LIGO PROJECT	
DATE	REV
DESIGNER	APP'N
CHECKED	DATE
BY	NO.
NTS	09600511-11A

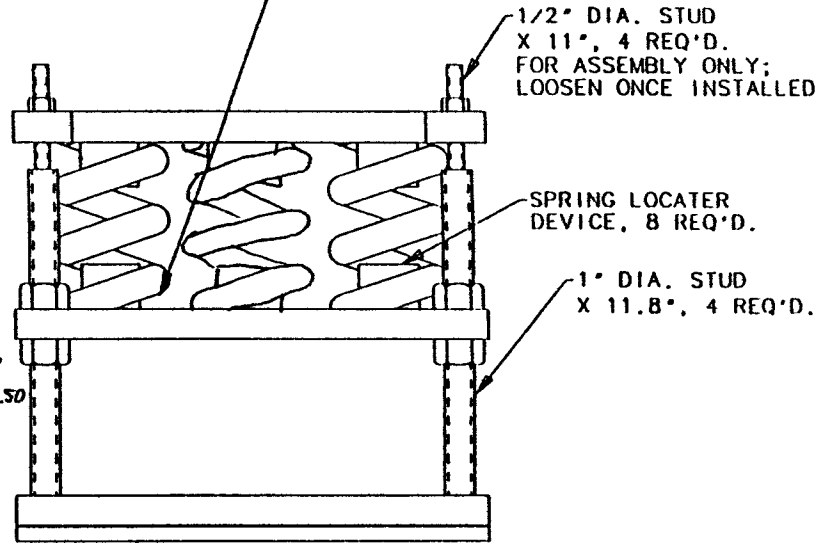
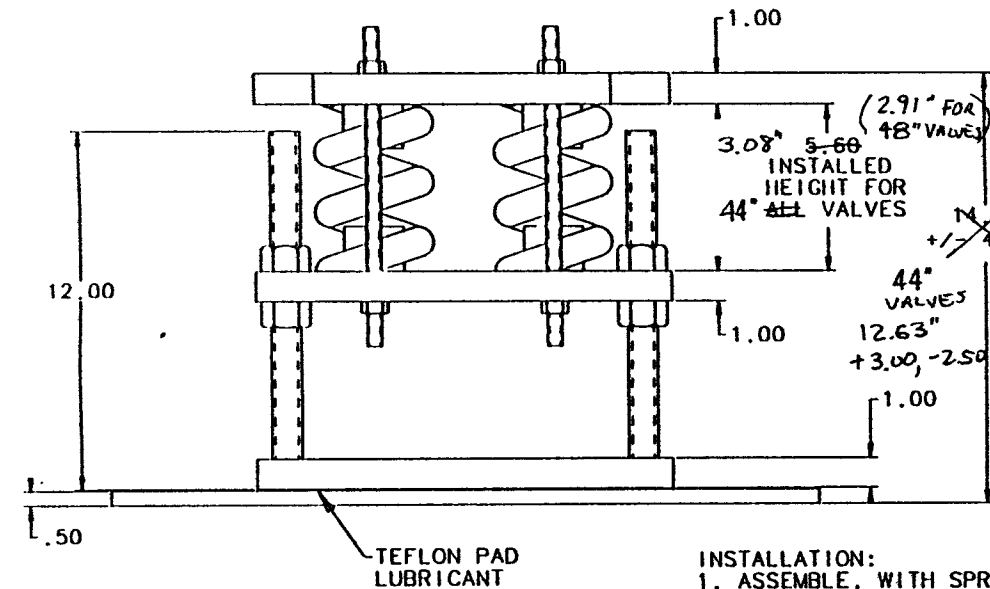
6
 DIE SPRING, 4 REQ'D.
 MCMASTER-CARR #9295K99 9295K94
 OR EQUAL. 1536 LB EACH
 AT 2 1/4" DEFLECTION.
 8" FREE LENGTH. 1603
 4" 1.2"

- INSTALLATION:
1. ASSEMBLE, WITH SPRING PACK HEIGHT AT 5.70" (44° VALVE), 2.96" (48° VALVE)
 2. MEASURE HEIGHT OF GATE VALVE BODY ABOVE SLAB
 3. BEFORE PLACING UNDER VALVE, ADJUST OVERALL SUPPORT HEIGHT TO VALVE HEIGHT, -0.05" BY ADJUSTING 1" NUTS
 4. LOCATE SUPPORT UNDER VALVE, WITH SPRINGS CENTERED UNDER VALVE FACE, PLATES AND SUPPORT CENTERED ON VALVE BODY
 5. ADJUST 1" NUTS UNTIL SPRING PACK HEIGHT IS 5.60" (44° VALVE), 2.91" (48° VALVE)
 3.08" (44° VALVE), 2.96" (48° VALVE)
 6. LOOSEN 1/2" NUTS AN ADDITIONAL 0.5"
